Horncastle House, Plawhatch Lane, Sharpthorne
Our Ref: 29528-FLD-0101 Rev A
Drainage Technical Note
November 2025

Revision A of this Technical Note aims to address comments from West Sussex County Council (WSCC) as the Lead Local Flood Authority (LLFA), dated 29th July 2025, see **Appendix A**. The LLFA comments are provided below in *Italics* and a MEC response is provided in normal text, addressing each comment.

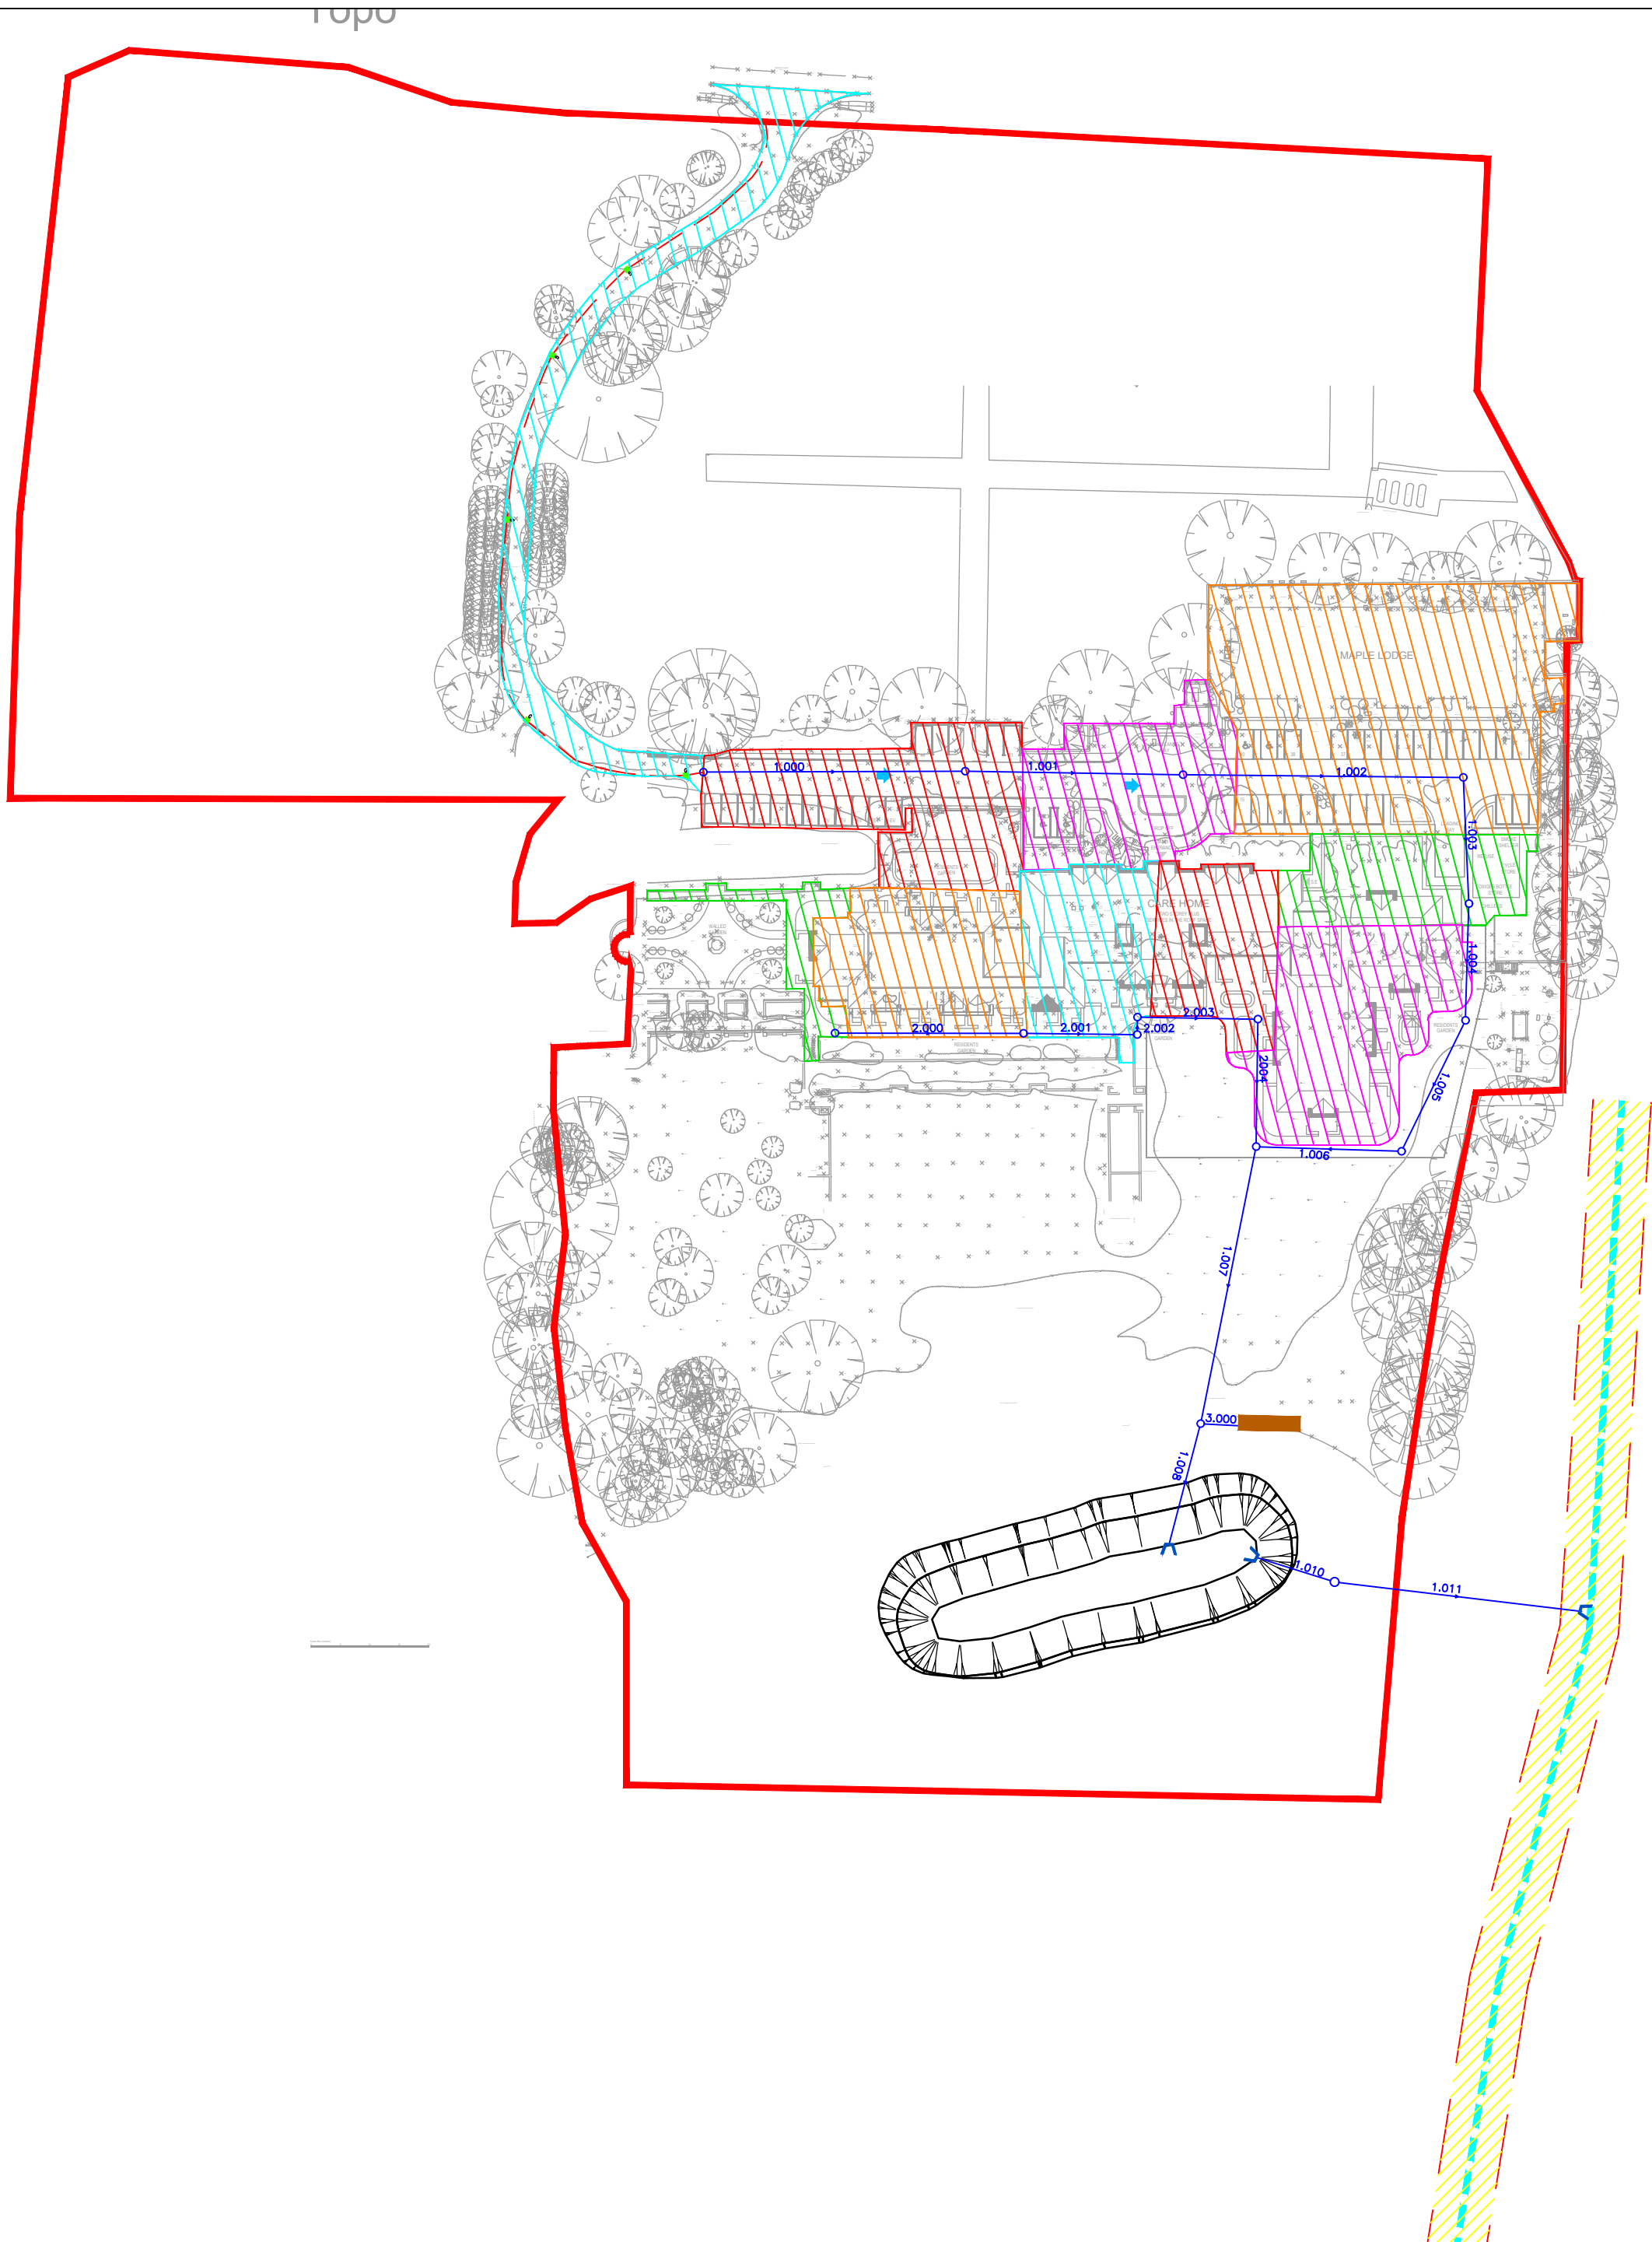
- *The hydraulic calculations are based on a site in Scotland (region 1). The drainage strategy and calculations will need to be updated based on the local region for the site.*

- *As this is a full planning application, full network calculations are required. The drainage layout must be labelled to allow for cross-referencing with the calculations.*

The calculations have been updated to be based on region 7 and can be found in **Appendix B**. This has decreased the QBAR calculation from 6.1l/s to 5.9l/s, but still provides a 95% betterment from the existing brownfield site. The drawing has been updated to reflect these changes in **Appendix C**.

Full network calculations, which include the pipe sizes and lengths have been included in **Appendix B** and the drainage strategy has been updated to show the pipe networks in **Appendix C**.

A surcharged outfall has been included within the calculations in **Appendix B**. The depths of the surcharged outfall have been set to 0.20m, which is the depth of surface water flooding around the watercourse.

DRAWING TITLE: IMPERMEABLE AREAS
DRAWING

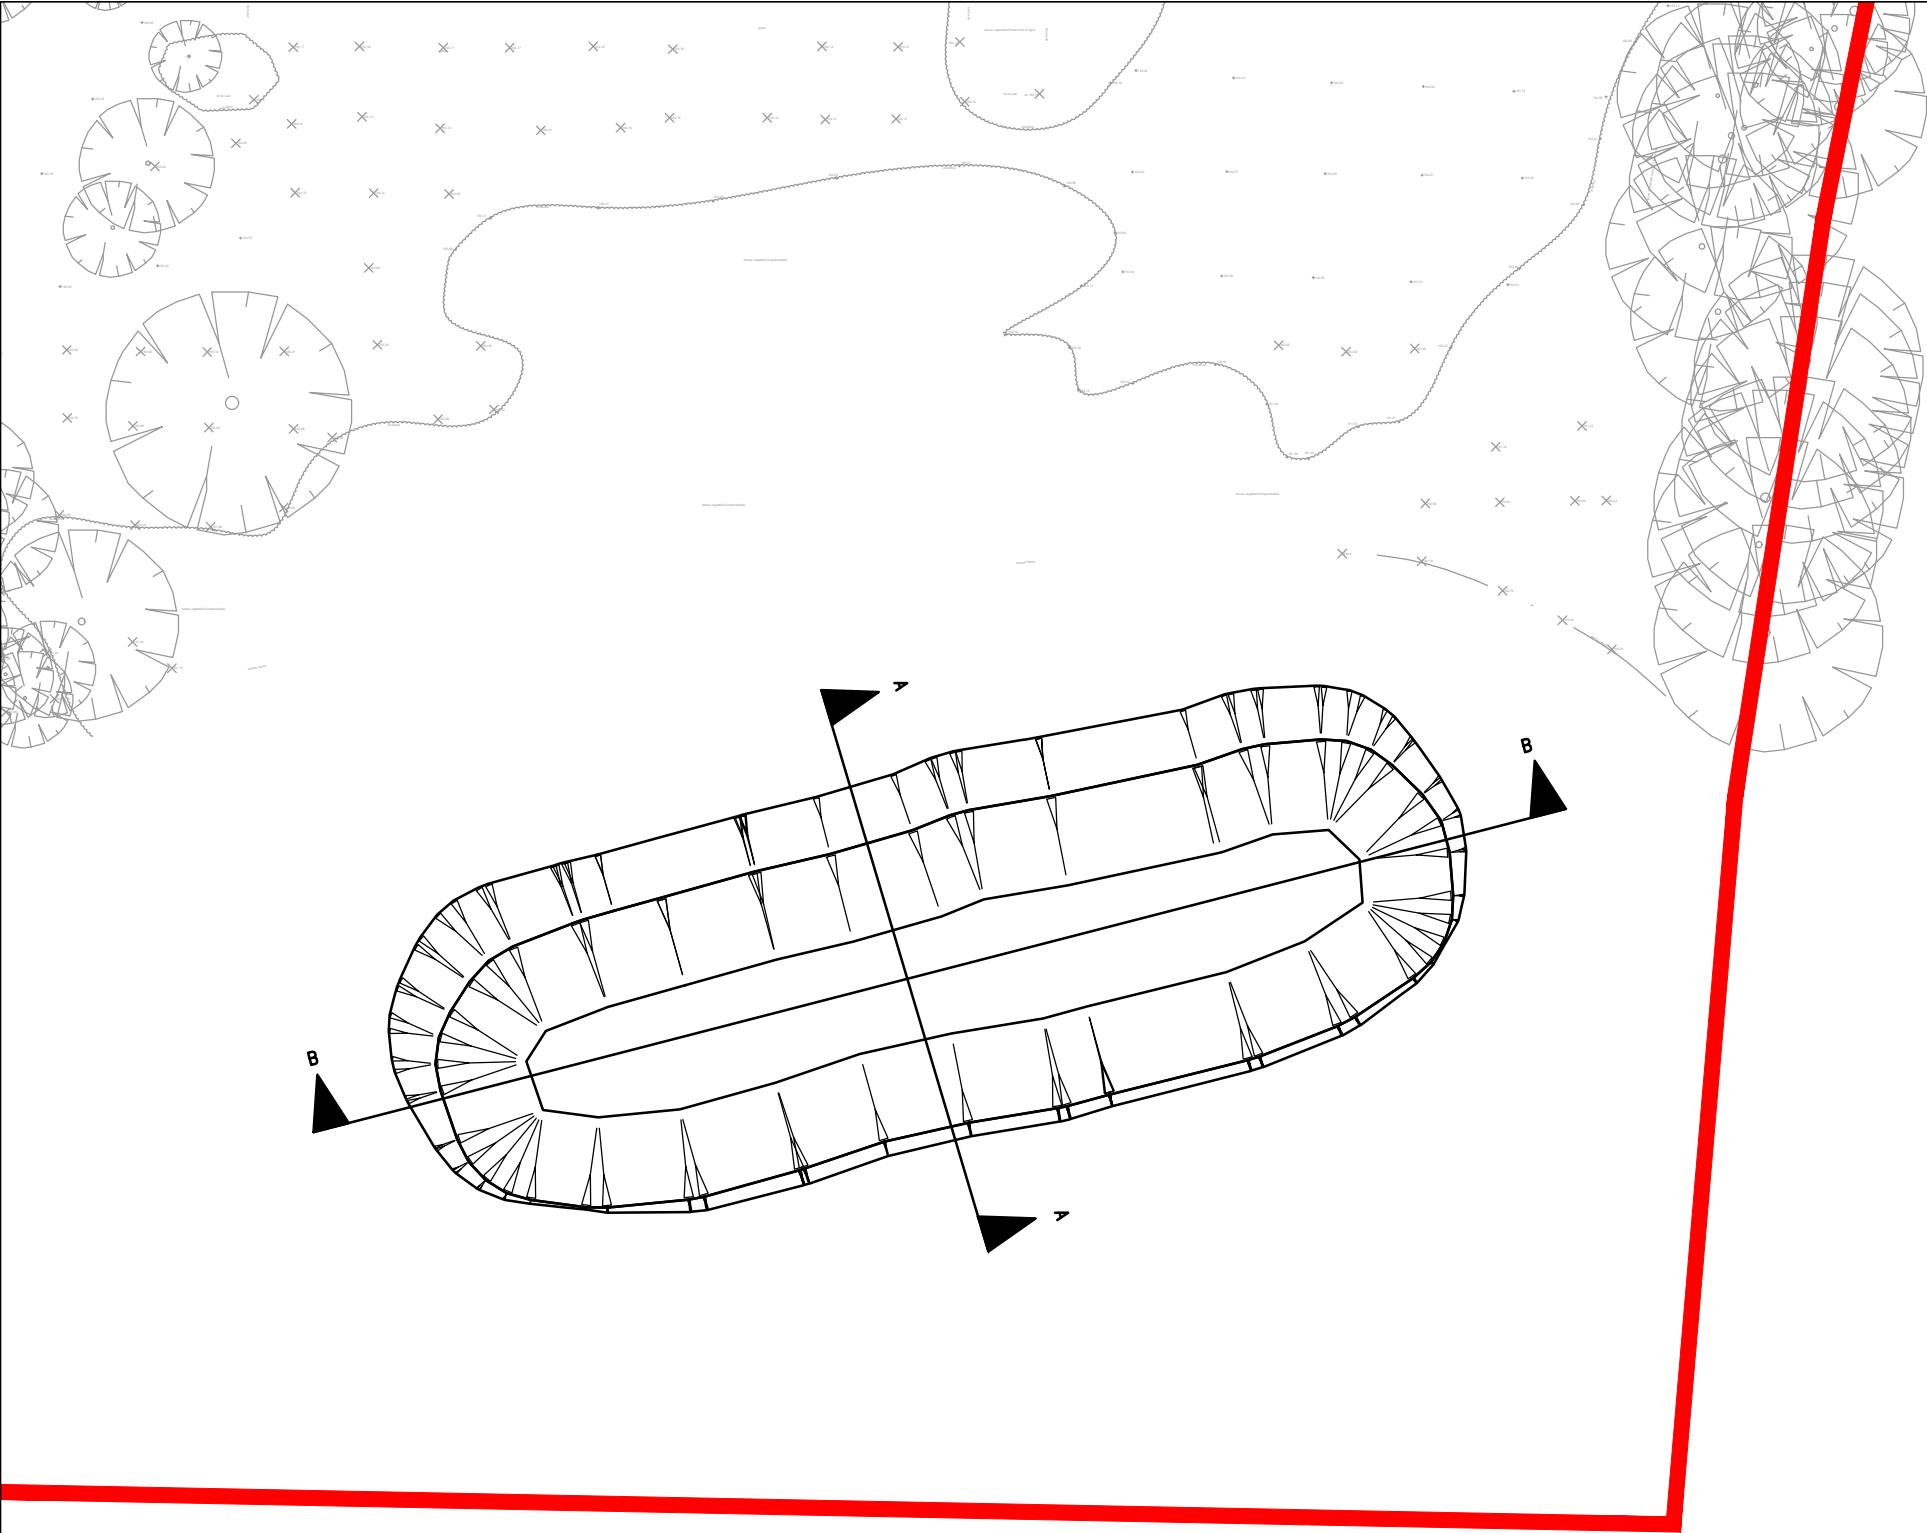
- *An impermeable areas plan is required.*

An impermeable areas plan is included in **Appendix D**, see drawing 29528_01_230_02.
